**PROPOSED REVISION 15**  
**AP1000 DESIGN CONTROL DOCUMENT**

**Tier 1 Figure 2.7.4-1**

**Diesel Generator Building Ventilation System**

**Description of Change**

**Figure 2.7.4-1 (Sheet 1 of 2)**  
**Diesel Generator Building Ventilation System**

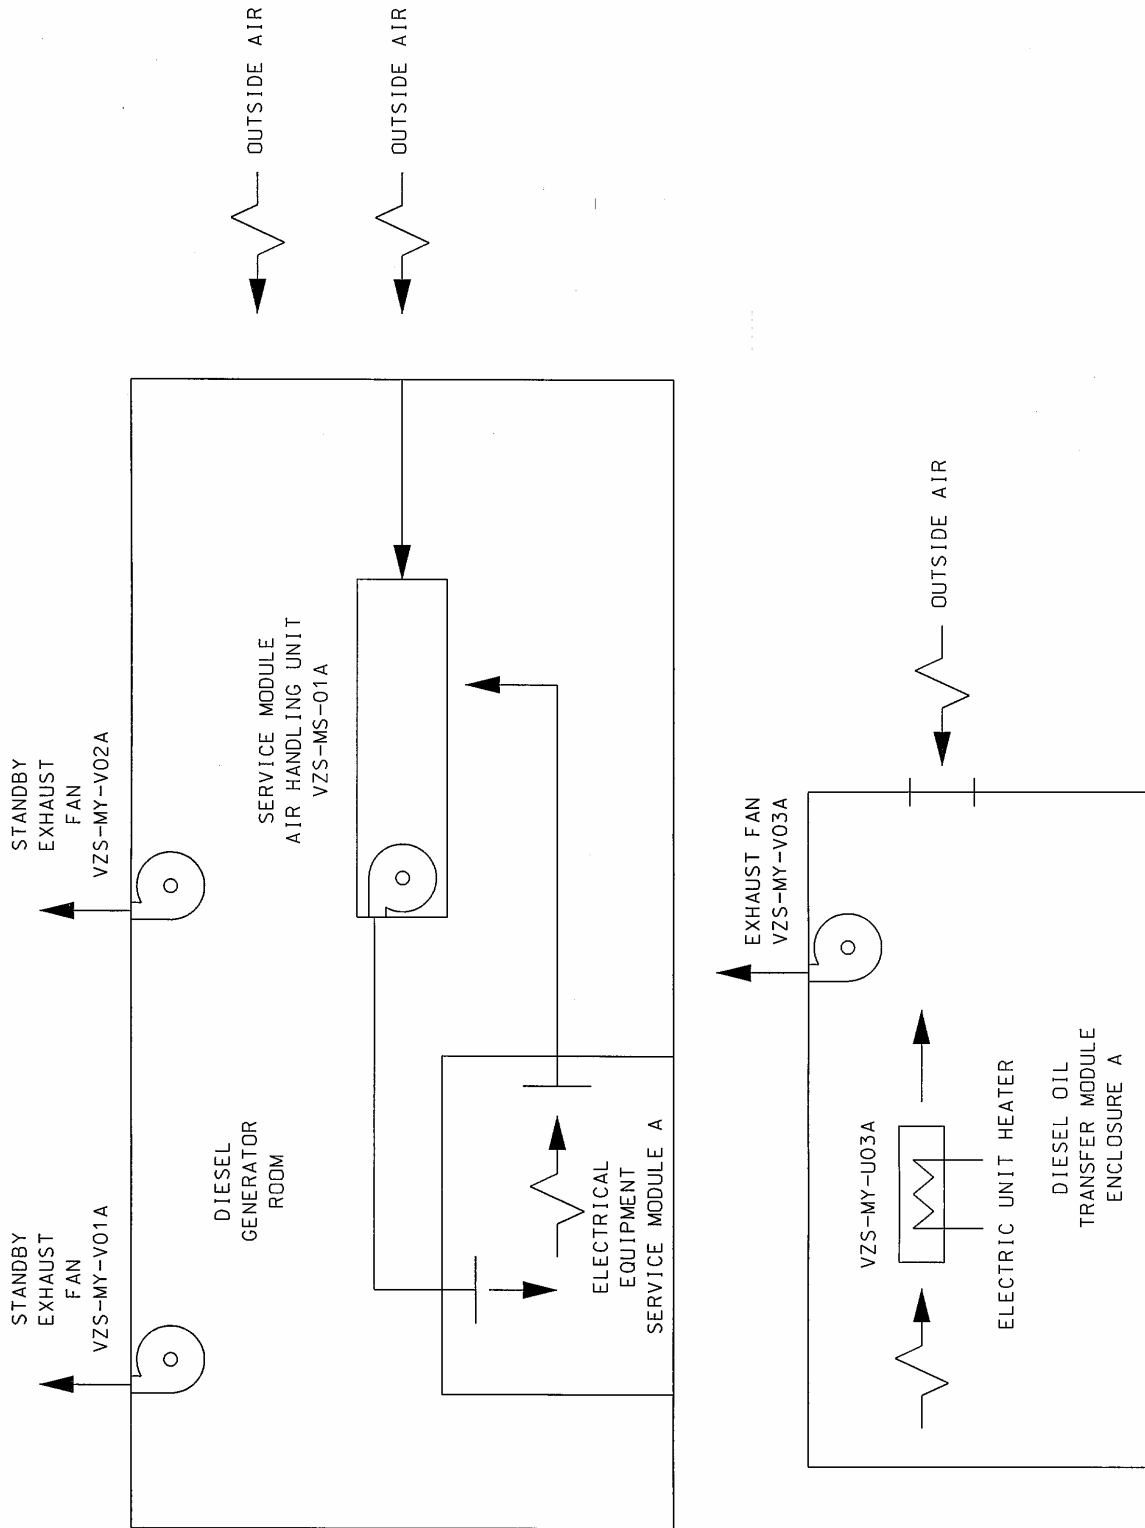
Correct certain tag numbers in Tier 1 Figure 2.7.4-1, sheets 1 and 2 of 2.

**Tier 1 Figure 2.7.4-1** Revise Tier 1 Figure 2.7.4-1, sheets 1 and 2 of 2, as shown on the next pages.
